**ADDENDUM NUMBER TWO (2)  
TO THE PLANS AND SPECIFICATIONS FOR:**

**NORTH ECHS  
AND  
COLLEGE & UNIVERSITY CAMPUS  
STUDENT RESTROOM RENOVATIONS**

**PSJA ISD  
Bid # 18-19-042  
Project No. 19.04**

**GIGNAC & ASSOCIATES  
3700 N. 10<sup>th</sup> STREET, SUITE 205  
McALLEN, TEXAS 78501  
(956) 686-0100**

2 ENLARGED ELECTRICAL PLAN  
EP2.12U 3/16"=1'-0"

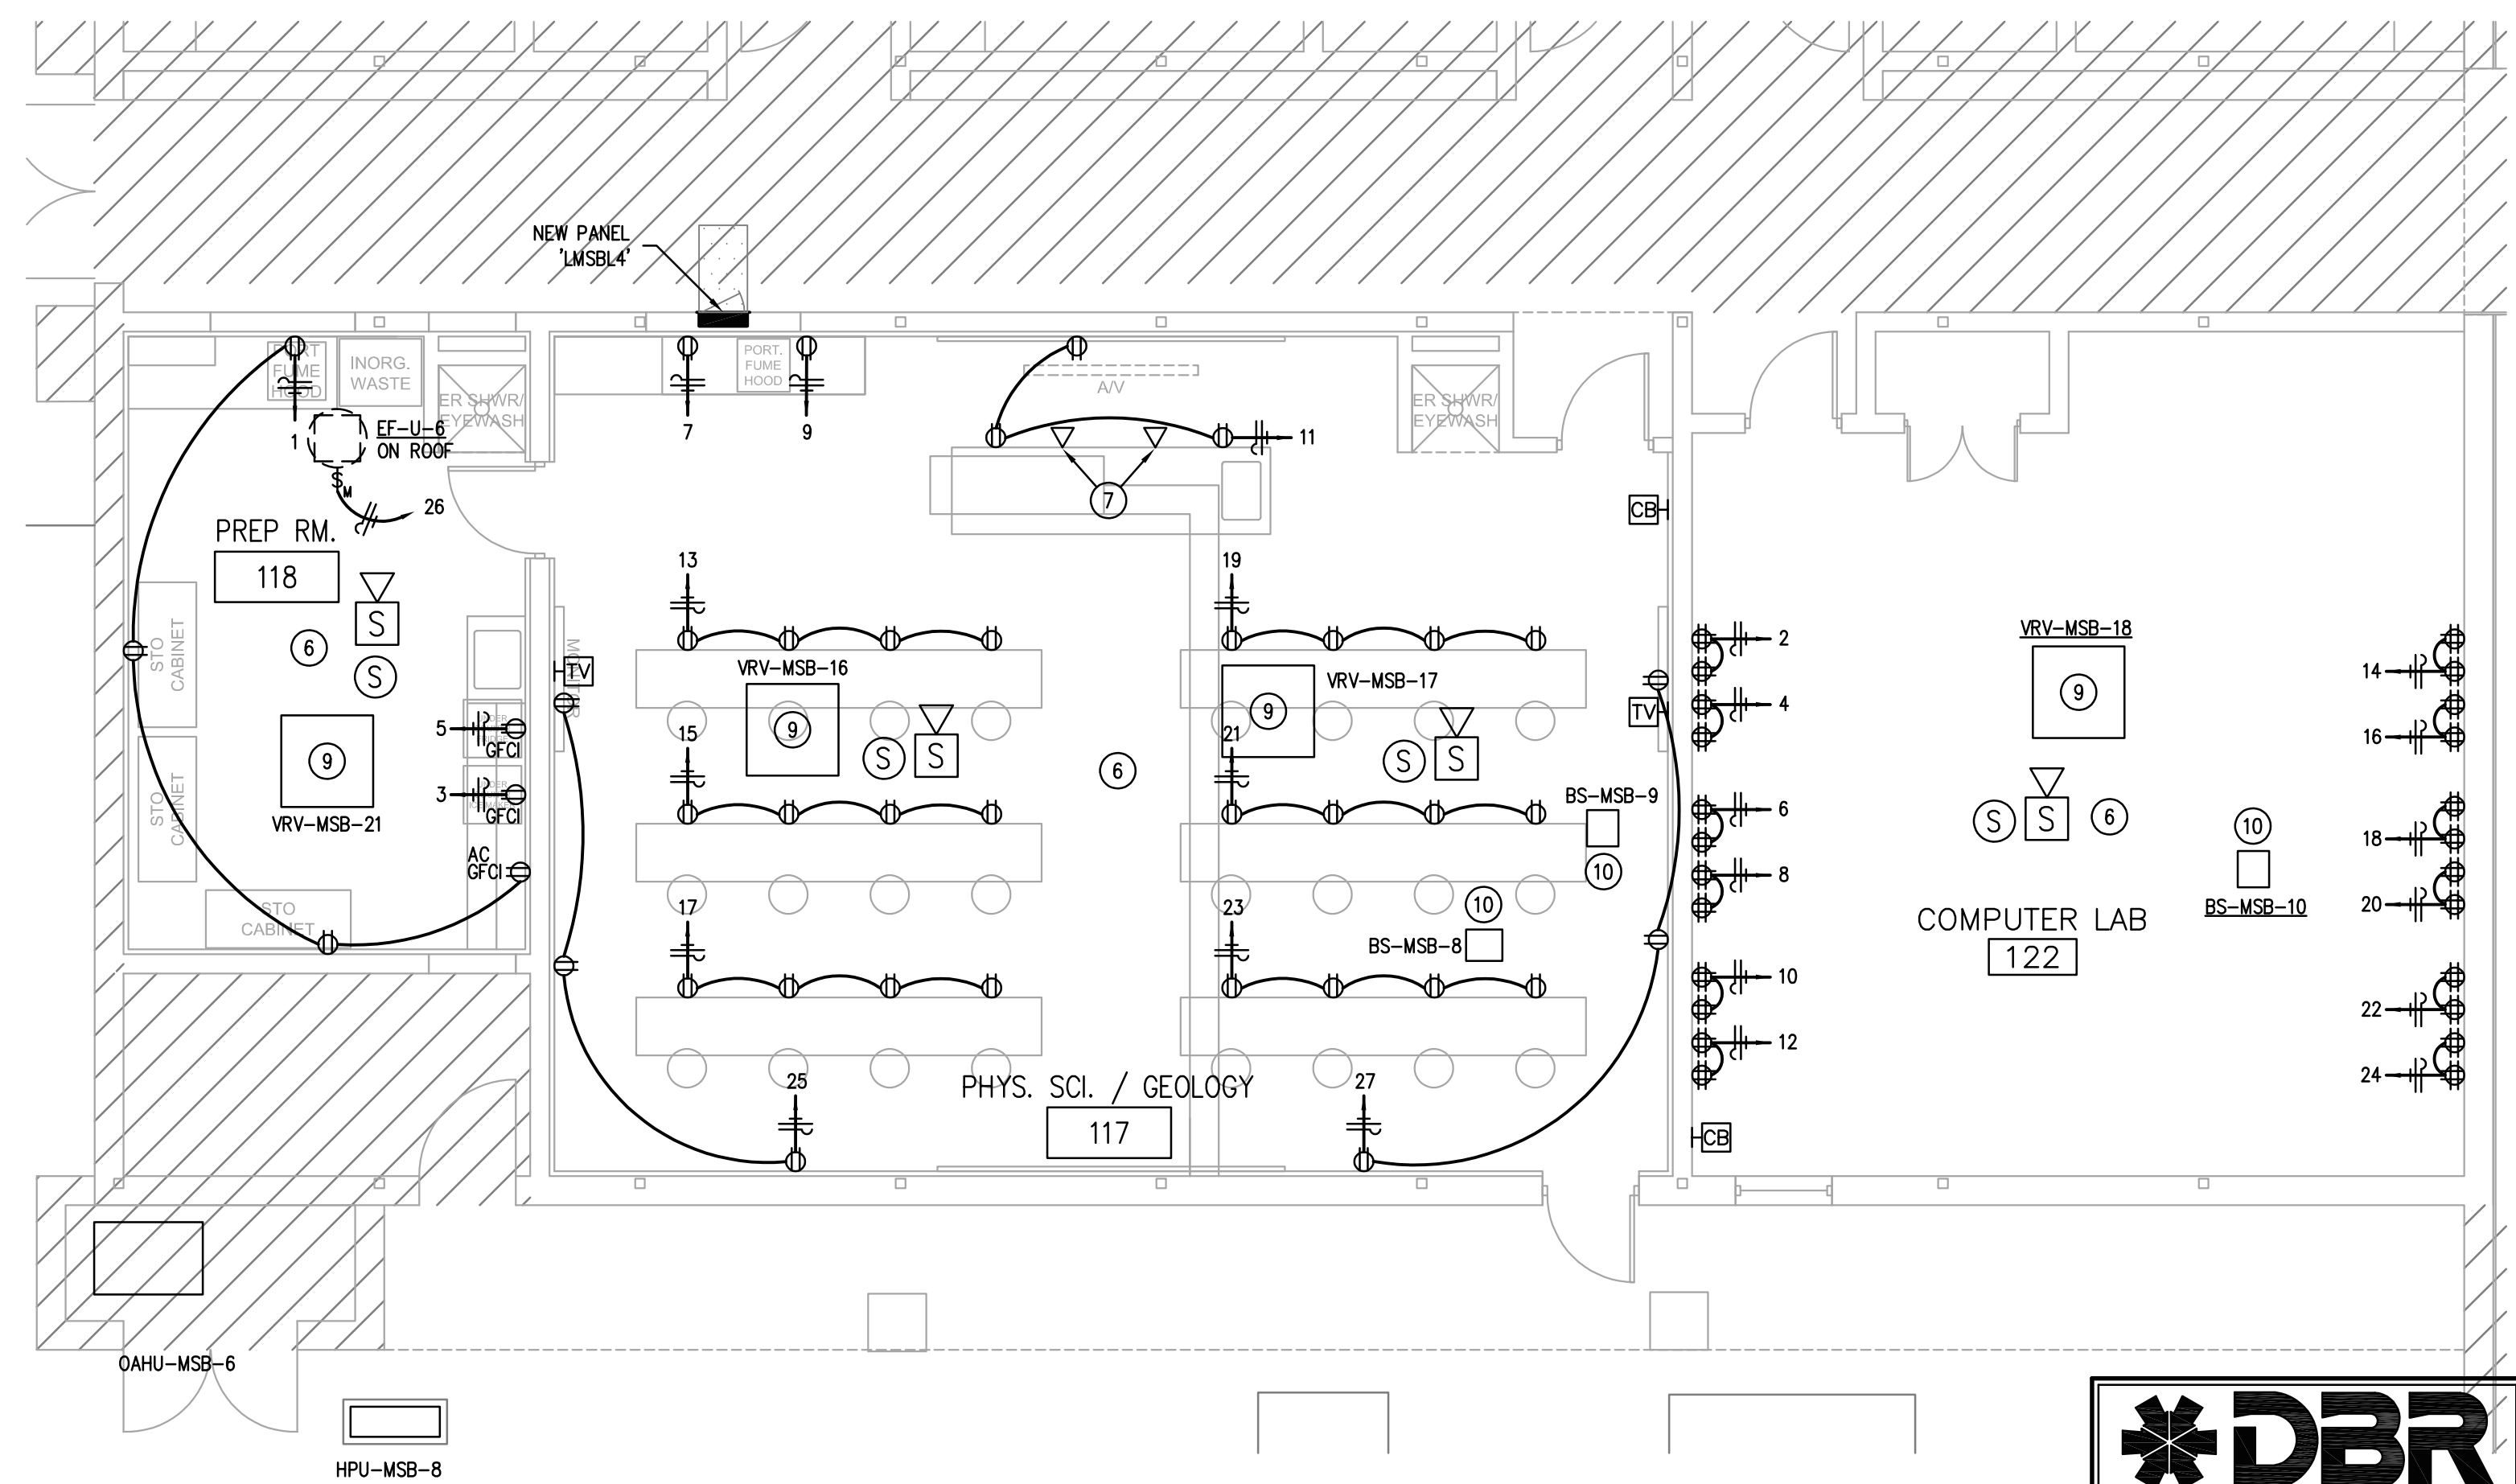
- A.      Removed electrical circuit information for roof top units. Re: EP 2.12U
- B.      Removed electrical circuit information for fume hood exhaust fans. Re: EP 2.12U
- C.      Modified electrical circuiting to lab hoods. Re: EP 2.12U
